STAFF REPORT

NEW BEDFORD HISTORICAL COMMISSION MEETING

CASE # 2022.04: CERTIFICATE OF APPROPRIATENESS

89 N Water Street Rehabilitation

Handicap Parking Area - Screening

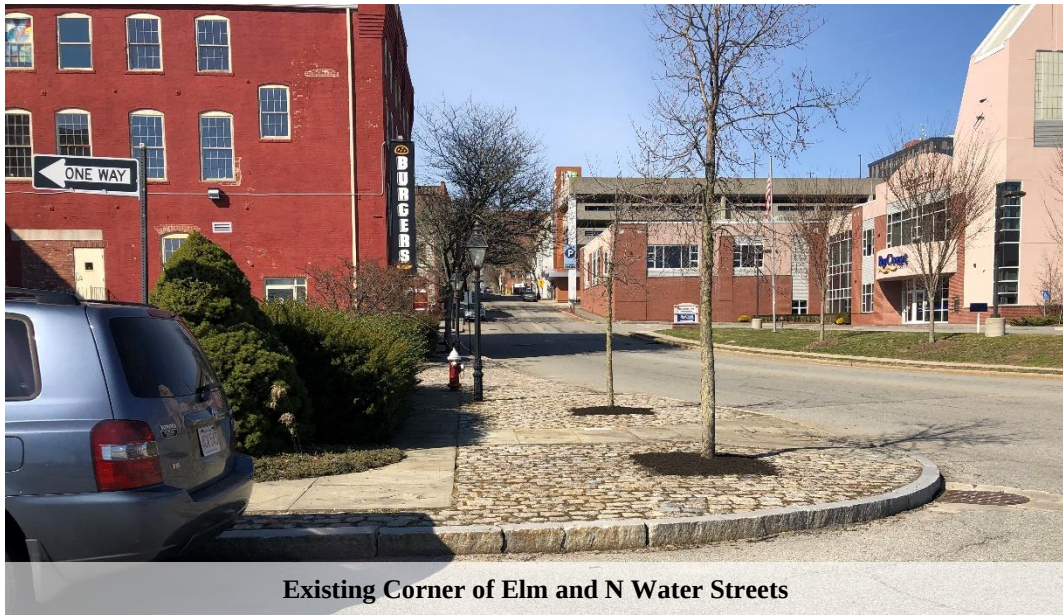
GUTTERS & DOWNSPOUTS	Current gutters and downspouts are white aluminum, and the applicant has indicated that the downspouts would be replaced, but no specifications have been provided.
MODERN EQUIPMENT	An elevator is proposed for the southwest corner of the building and may be minimally visible from the public way, and the applicant has indicated that they would paint the overrun to match the building. A height of the elevator over run has not been submitted. The applicant has indicated that the HVAC units will be located on the roof, however the submitted roof plan does not indicate as such.
LIGHTING	No new lighting is being proposed, however the Board may wish to discuss the possible replacement of the inappropriate LED wall-packs with exposed conduit located on the east façade in the parking lot.
PARKING LOT	- Plans indicate that existing landscaping within the public way along the north edge of the parking lot is to remain and additional shrubs to be added along the proposed closed curb cut. The applicant has stated they would improve and maintain the landscaping, which is within the public way. - Fencing is proposed north of the parking area behind the shrub row based on earlier feedback from the Historical Commission. No screening is proposed along the east edge of the parking lot on N Water Street. The Board may wish to discuss fencing/screening and parking as described above with the applicant.

Existing Elm Street entry proposed to be closed

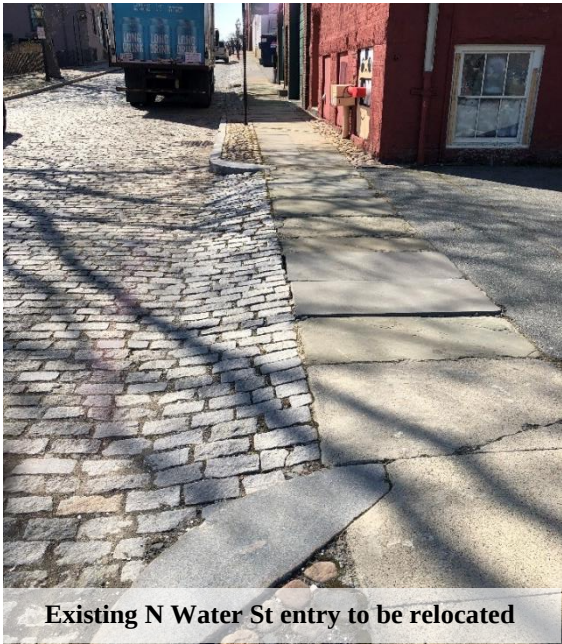
The existing parking lot will be reconfigured to remove the drive entry and curb cut along Elm Street and move the existing drive entry along N Water Street northward to align with the center of the parking lot. The applicant has consulted with DPI to relocate the existing crosswalk northward to the Elm and N Water Street intersection and all appropriate sidewalk and street materials will be utilized.- under DPI's supervision. A partial landscape buffer exists along the Elm Street edge of the parking lot, and the applicant has proposed to extend the landscape buffer west to fill in the closed off Elm Street entry. A single handicap parking space and trash/mechanical screening will be located on the south side of the building within the courtyard accessed from Bethel Street. A new fence and gate, acting as the screening, and may be used for access to a building entry, has not been specified.
